R37-2025

Denial of a Certificate of Appropriateness – 927 Turner Street

HDC-2024-00117

Address: 927 Turner Street

Current Front Elevation (City of Allentown)

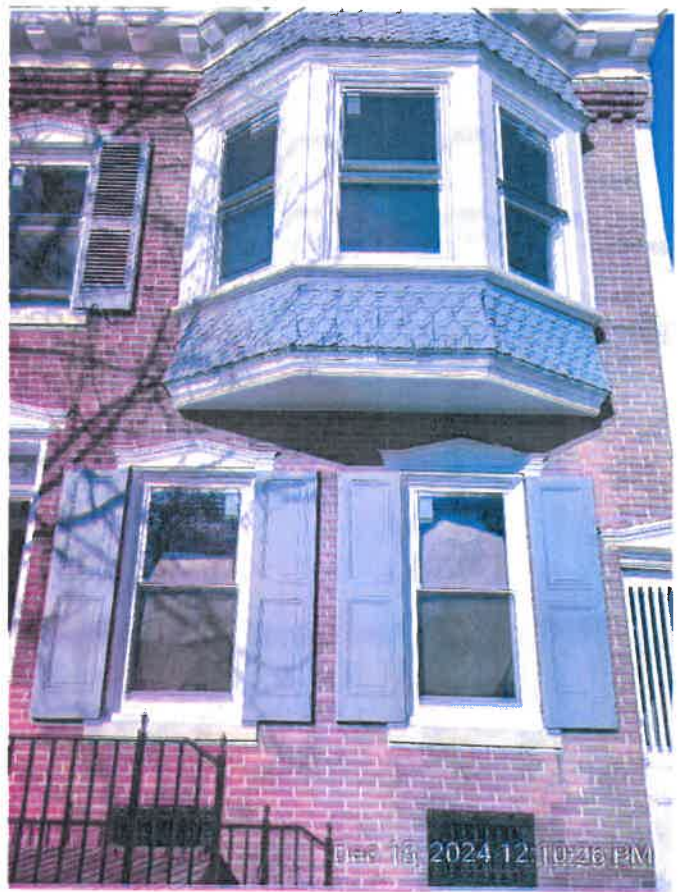
Observations & Comments: The installed vinyl windows are not appropriate per the Guidelines. It would be helpful if the owner/applicant can provide detailed photos of the windows prior to replacement, or evidence that they needed to be replaced rather than repaired. It appears that the configuration of the rear windows was not replicated in the replacement windows; they were previously two-over-two and are now one-over-one. A more appropriate replacement window would be wood windows, aluminum-clad wood, composite wood, or fiberglass.

Staff Recommendation: It is recommended to deny the application.
